Product Change Notice (PCN)

PCN Number: PCN-0456169R-01

Product(s) Affected: PJ-031CH

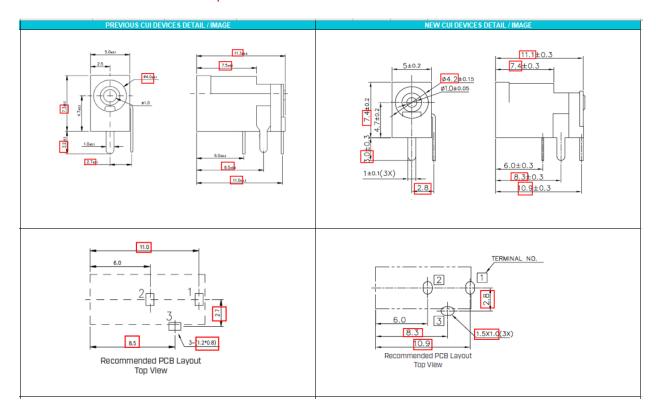
Description of Change: Product re-engineered for improved manufacturability and production yield. See image below for product changes. Cosmetic differences may be visible and not affect the form fit and function of the product.

DESCRIPTION MATERIAL PLATING/COLOR Center pin brass silver terminal 1 brass 1-0.50 silver terminal 2 MM allox 1-0.20 silver terminal 3 brass 1-0.50 silver housing PA10T (UL84V-0) black MATING PLUG MATING PLUG DESCRIPTION MATERIAL PLATING/COLOR Center pin brass Cusn terminal 1 brass 1-0.40 silver terminal 2 stainless steel t=0.20 silver terminal 3 brass 1-0.20 silver housing PA10T (UL94V-0) black MATING PLUG MATING PLUG MATING PLUG MATING PLUG MATING PLUG MATING PLUG
MATING PLUG Jack Insertion Depth: 7.0 mm
Jack Insertion Depth: 6.2 mm
